Office Action Summary	Application No. 09/585,472	Applicant(s) SAKAMOTO, MICHIAKI	
	Examiner Timothy L. Rude	Art Unit 2883

DETAILED ACTION

FIG. 6(c)

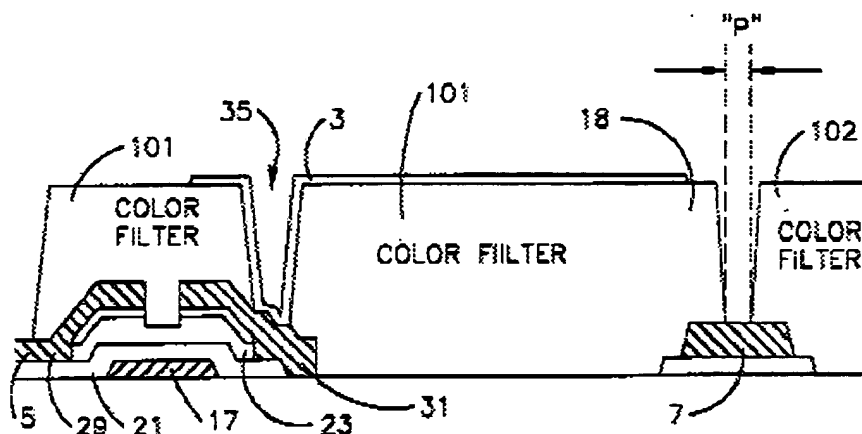
As to claim 1, Zhong discloses (entire patent, especially Figures 6(a)-6(c) and 11) an active matrix liquid crystal display device (col. 8, line 22 through col. 11, line 28), comprising: a first substrate, 19, and a second substrate, 51, at least one of said first substrate and said second substrate being transparent; a plurality of scanning lines, 7, formed on said first substrate; a plurality of signal lines, 5, formed on said first substrate crossing said scanning lines in a matrix manner a plurality of thin film transistors, each said thin film transistor respectively formed at an intersection of said scanning lines and said signal lines, each said thin film transistor comprising: a gate electrode, 17, formed on said first substrate; a gate insulation layer, 21, formed on said gate electrode; a semiconductor layer, 23, formed on said gate insulation layer; a drain electrode, 29, formed on a first portion of said semiconductor layer and a first portion of said gate insulation layer; and a source electrode, 31, formed on a second portion of said

semiconductor layer and a second portion of said gate insulation layer; at least one color filter, 101, formed on said first substrate; a plurality of pixel electrodes, 3, each respectively connected to one of said thin film transistors through a contact hole, 35, and each respectively formed on one of said at least one color filter; a counter electrode, 49, formed on said second substrate; and a liquid crystal layer, 45, between said first substrate and said second substrate, said liquid crystal layer being driven by electric fields between said pixel electrodes and said counter electrode to thereby make a display, wherein said color filter is formed directly on said first substrate (per Figure 6(c)) in substantially all of a light transmission region within a pixel area surrounded by said scanning lines and said signal lines, providing an efficient high aperture display [Abstract, Applicant's a thickness of said color film forming said color filter being a preselected first thickness that provides a sufficient chromaticity for said color filter; please note that the display of Zhong has a preselected first thickness that does provide the color display of Zhong with efficient high aperture display performance, per Zhong], and said color film comprises a stack of layers [stacked on top of transistor layers] that reduces a thickness of material of said color filter near said contact hole such that said second thickness is processed successfully to form a functional contact hole [Applicant's thickness chosen to permit a photo-crosslinkage to occur in an entire thickness of said second thickness of said color filter material during an exposure processing of said contact hole] (per Figure 6(c)).

Zhong does not explicitly disclose a display comprising a passivation film formed on said thin film transistors; at least one color filter additionally covering said passivation film; wherein said passivation film and said color film form a stack of layers that reduces a thickness of material of said color filter near said contact hole such that a portion of said passivation film remains in place adjacent to said contact hole.

Zhong teaches the use of a color filter, 101, consisting of a photosensitive organic film (resist) with a color pigment or dye (col. 16, lines 43-46) that is substantially flat on the top surface (as illustrated in Figure 6c), therefore a difference in level generated on a surface of the organic film being not more than $0.3\ \mu\text{m}$ as a results effective variable for reducing line-pixel capacitances (Abstract) (MPEP 2144.05 II B).
